INDESIT company

Model type:
LL43SEU

Commercial code:
F030412

n1045085: Introduction of new litre counter turbine integrated on air-break.

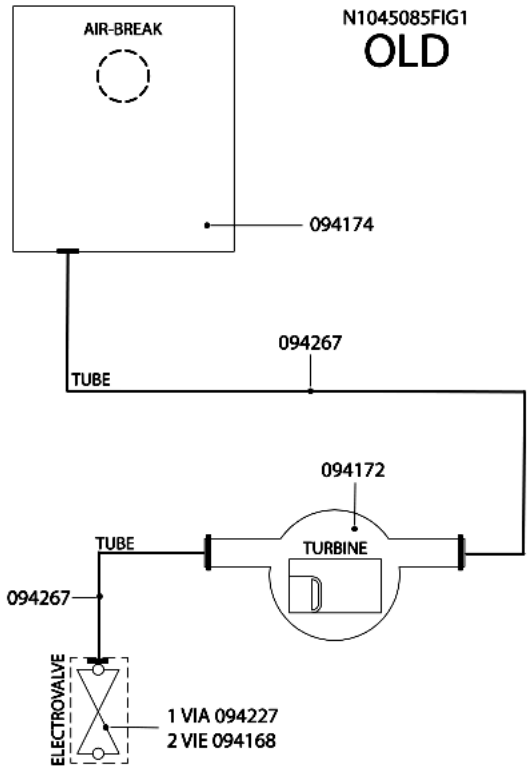
All dishwashers affected by this note have been equipped with a new litre counter turbine on the air-break.
Picture N1045085FIG1 illustrates the premodification structure, picture N1045085FIG2 the new structure.

Items affected by the modification.

AIR-BREAK:
new 110610;
premodification 094174;
the new item features a new integrated litre counter turbine and its water supply hose has a smaller diameter.

LITRE COUNTER TURBINE code 094172 has been eliminated.

SOLENOID VALVES:
new:
1-WAY code 110611;
2-WAY code 084558(Rohs 143737);
premodification:
1-WAY code 094227;
2-WAY code 094168;
the new solenoid valves have a smaller diameter drain hose fitting.

HOSES:
new solenoid valve hose/air-break code 110612;
premodification turbine hose/air-break code 094267;
premodification solenoid valve hose/air-break code 094267;
the new hose has a smaller internal diameter.

WIRING:
the litre counter turbine connecting cable is longer, but since the connector is the same, the new item can be used in place of the premodification one.

n1045128: New airbreak - solution of water spurts leaking from base LVS 45 CM

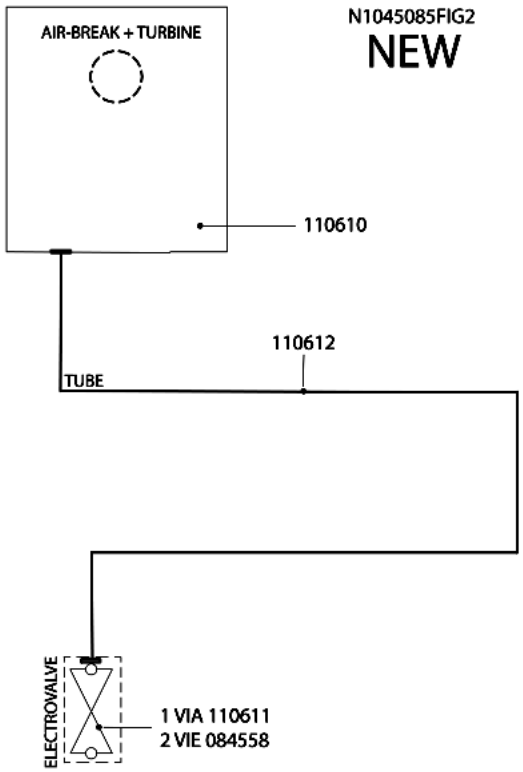
From serial number 50930.0001, to solve the problem of water spurts emitted from the lower right and left side of the door the following modifications were introduced in production:

1-Airbreak without insert to allow the necessary pressure venting
2-Honeycomb top panel to protect the kitchen unit from any steam emitted (only on built-under models)
3-Tank seal length increased by 3 cm to improve water tightness
4-Two clips for correct fixing of the tank base seal (in production from serial number 50701.0001)

New parts:
C00141308 - Airbreak
C00141514 - Honeycomb top panel (built-under versions only)
C00141316 - Tank seal
C00140679 - Tank base seal fixing clip

Premodification parts
C00110610 - Airbreak
C00116516 - Tank seal

1) AIRBREAK REPLACEMENT
It is mandatory to use the new part; in the event of replacement with premodification appliances proceed as follows:
- replace the airbreak with the new part C00141308
- on the built-under version, fit honeycomb panel C00141514 on the top of the appliance
- replace tank seal with the new seal P/N C00141316

WARNING: when replacing an airbreak without a litre-counter turbine use exclusively the same type of part (P/N C00094174 - all the relevant details are given in bulletin n1045085)

2) CHANGING THE TANK SEAL
On appliances with serial number from 40101.0001 to 50930.0001, you can use the new tank seal P/N C00141316 after cutting 1.5 cm off each end.
